| Title - Sujet Victoria SAR Station Construction | |
| Solicitation No. - N° de l'invitation F1700-184521/A | Amendment No. - N° modif. 005 |

Amendment 004

*The following changes in the Tender Documents are effective IMMEDIATELY.
This addendum will form part of the Contract Documents*

9
A7.03

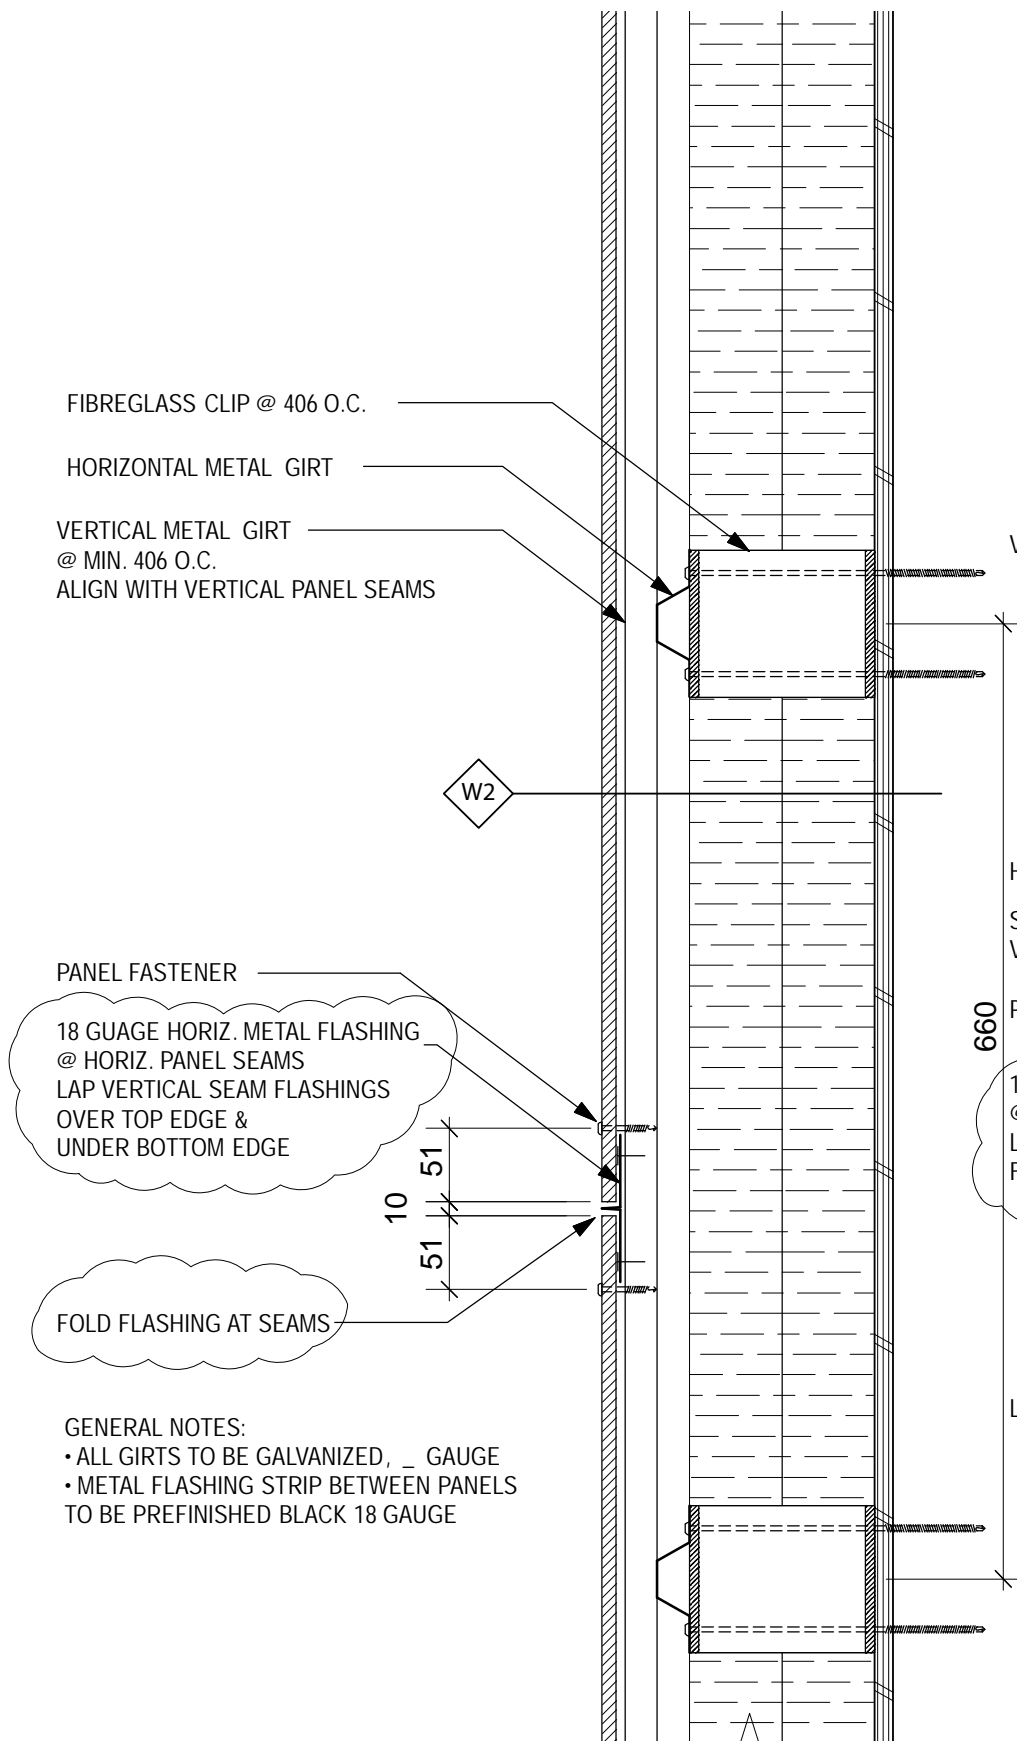
6. Drawing A7.03

See attached revised details 9 & 10. Revisions to notes bubbled.

| Project No. 105 du projet 2017567 | Sheet / Feuille E2.2 | Revision n.° / La Révision n.° |

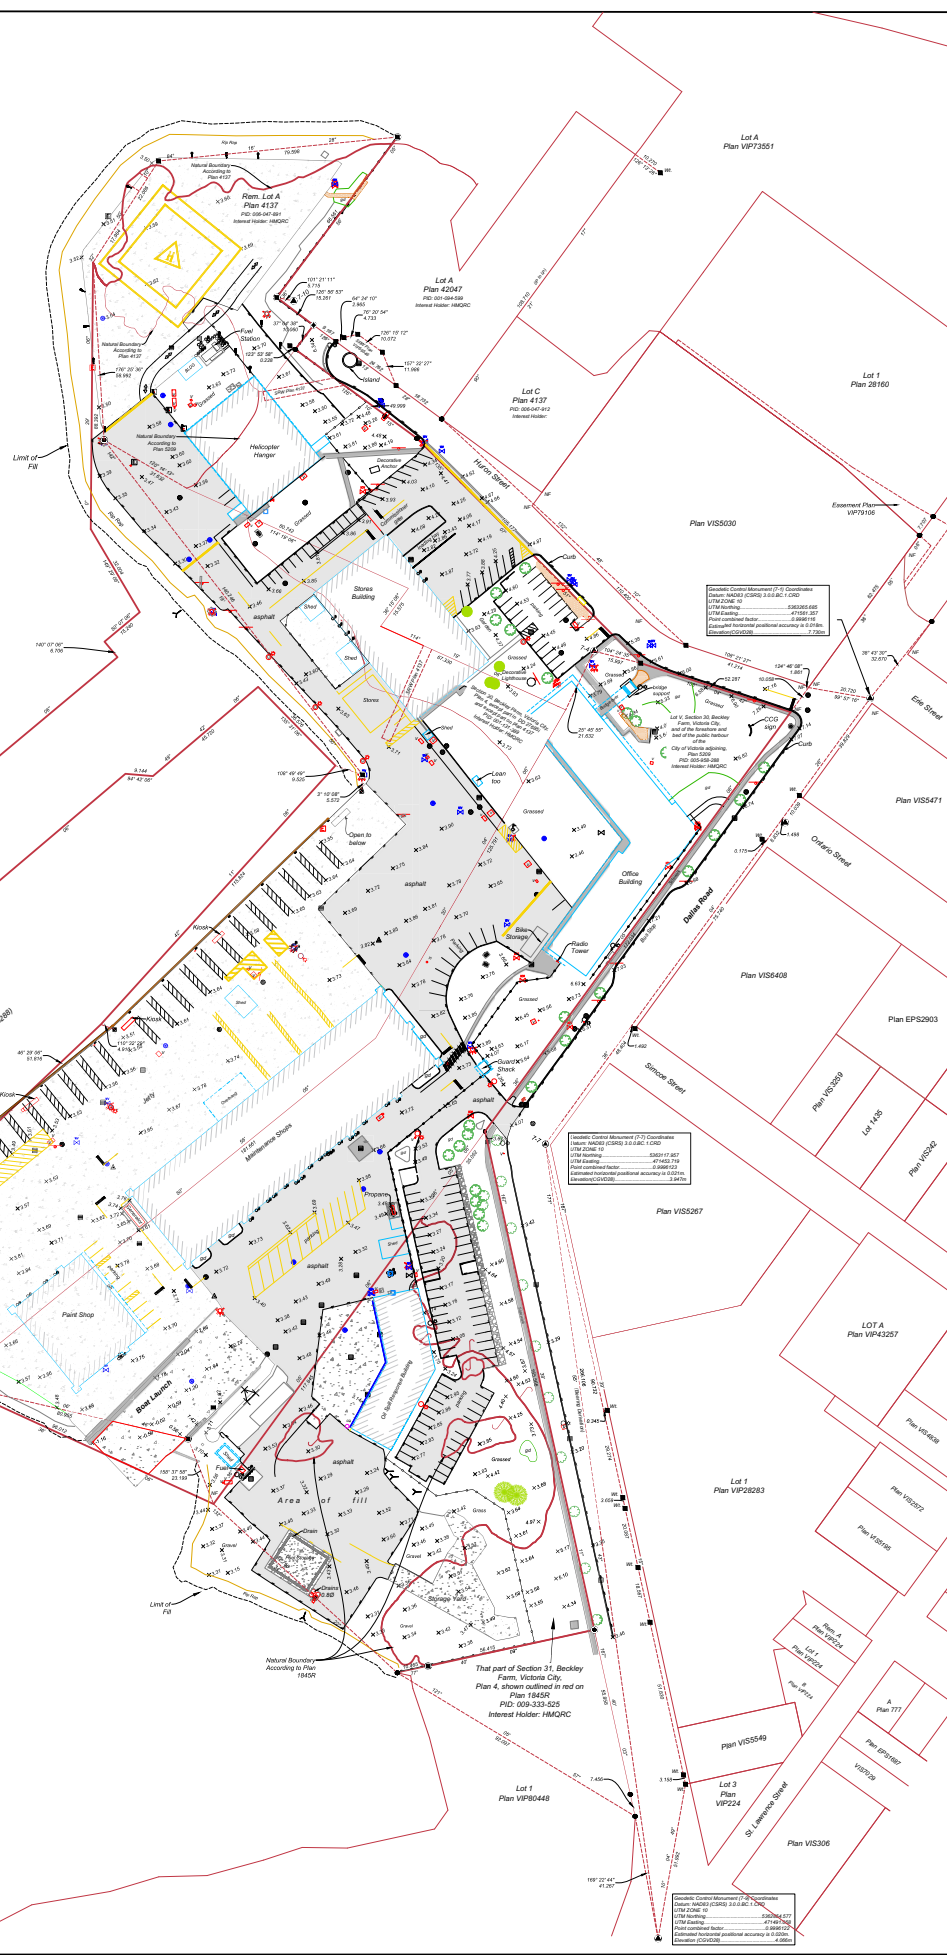
1. Drawing E2.2 (see attached)

Notes 1 -3 for detail 5/ E2.2, clarified.
